**BZA-2081**  
**PATRICK R AND MELINDA C O'NEIL, TRUSTEES OF THE**  
**PATRICK R O'NEIL AND MELINDA C O'NEIL**  
**REVOCABLE LIVING TRUST**  
**(variances)**

**REVISED STAFF REPORT**  
**July 21, 2022**

Petitioner is proposing to demolish the existing two dated apartment buildings and construct a new 5-story single apartment building, with parking located partially under the building and 32 one- and two-bedroom apartments on the upper floors. The site is commonly known as 418 Harrison Street, West Lafayette, Wabash 19 (SW) 23-4.

SHEET NUMBER:  
**A1**

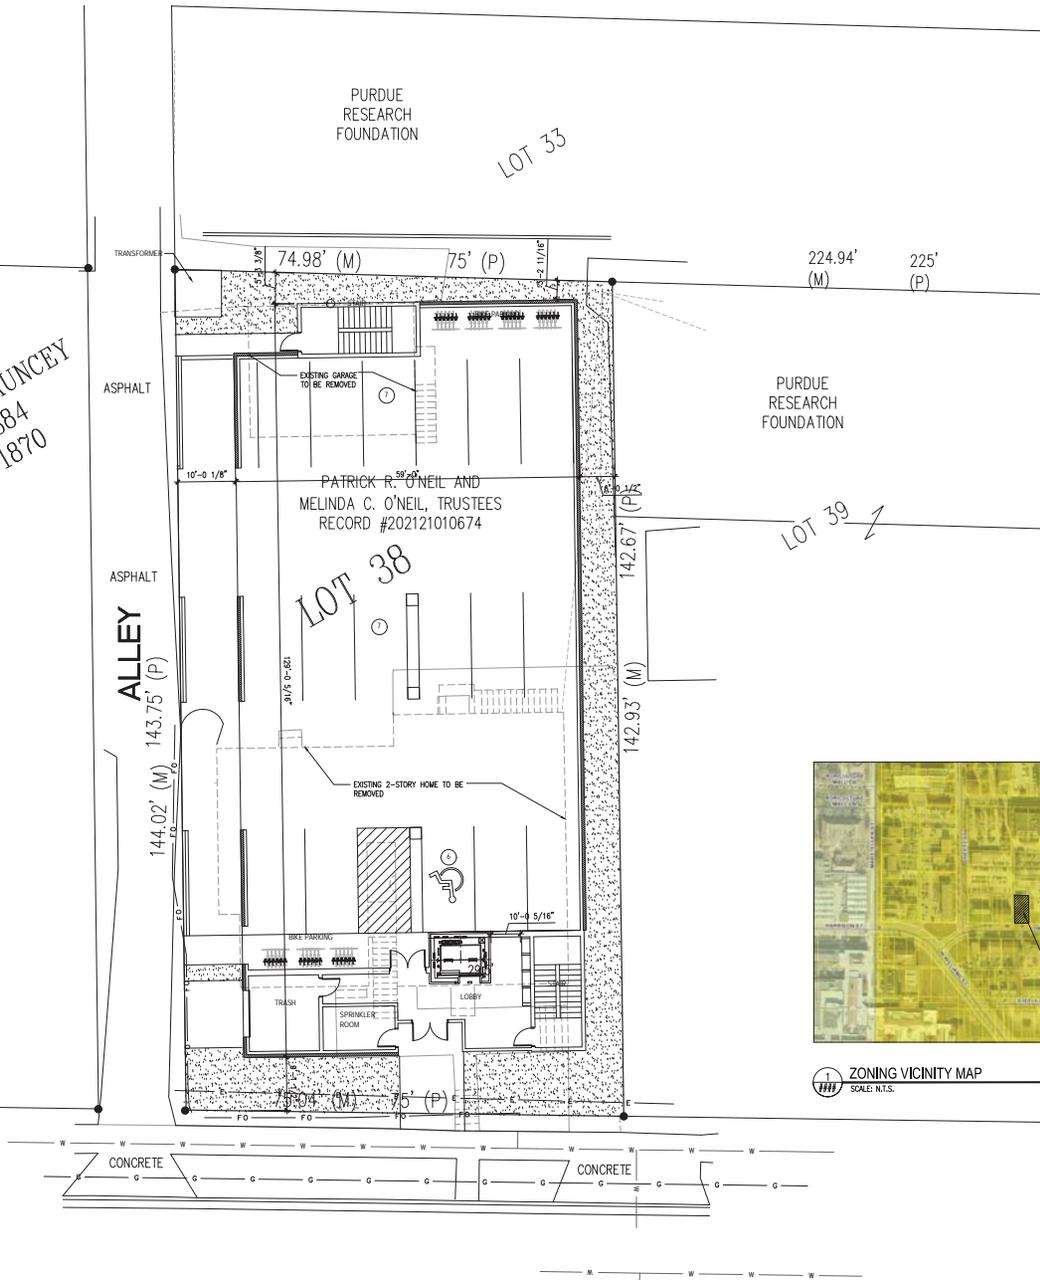
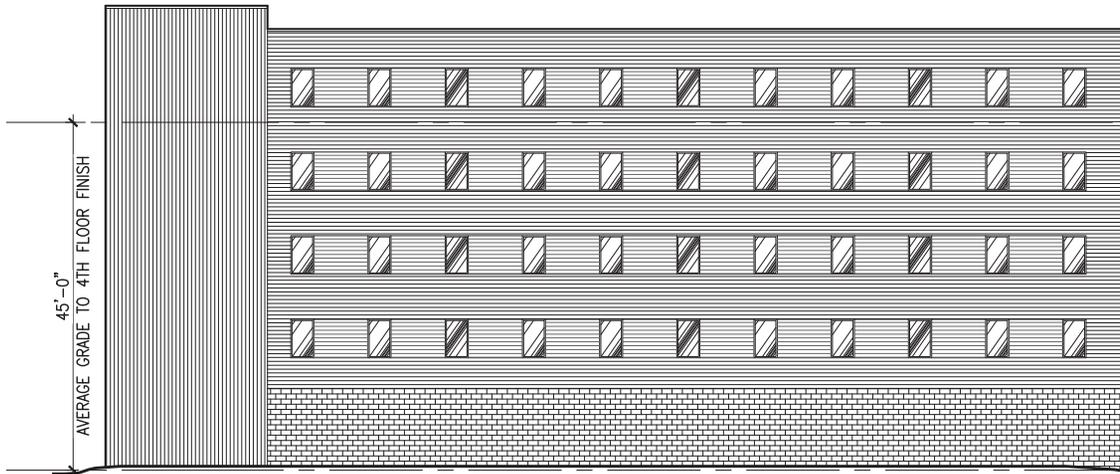
Requests #2 and #3 (lot coverage and vegetative coverage) would allow the building to cover 69.5% of the lot instead of the maximum allowed 40% as well as have 17.1% greenspace instead of the minimum required 30%. These requests are needed to accommodate the large footprint of the building in relation to the small lot size.

setback along a local road such as Harrison Street is 25 feet; petitioner is requesting a setback of 9 feet 1 inch (#4). (If averaged, the allowable front setback here would be 20'.) The required rear setback is 25 feet but request #5 has been amended to provide a 3-foot setback instead of the originally requested 0 feet.

And finally, request #8 would eliminate the 5-foot no-parking setback along the western property line. The western lot line is adjacent to a platted alley. The no-parking setback requirement ensures that the front and rear of parked vehicles does not protrude over a property line. The submitted site plan shows three spaces parallel to the western property line. The other three sides of this lot all meet this 5-foot no-parking setback. Because the parking spaces are parallel to the alley, they minimize the potential for overhang. Staff can support this request for this reason.
